HARTING Product Change Notification

PCN/21/007/C+N/US

Title: Change to InduCom Hoods

Date: 04/12/2021

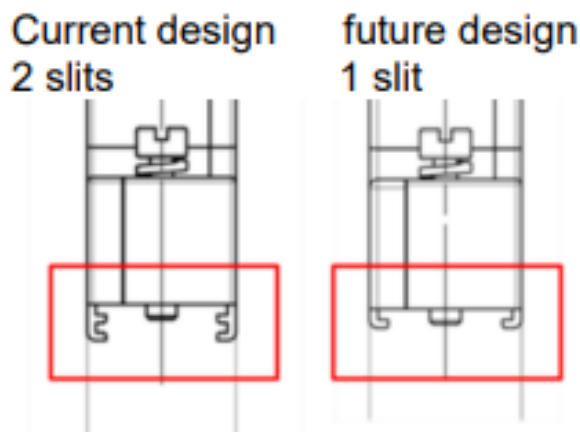
At the end of 2019 HARTING changed the design of the Inducom hoods. At the outer side of the hoods a 2nd slit was added (see picture below). This slit was intended for use with a mechanical coding option to be launched in the future. Please be informed, that HARTING will eliminate this 2nd slit. With this change the overall length of the hoods will be reduced to the same dimension as the pre-2019 design

When the new coding system is introduced we will create separate part numbers for the corresponding hoods with two slits.
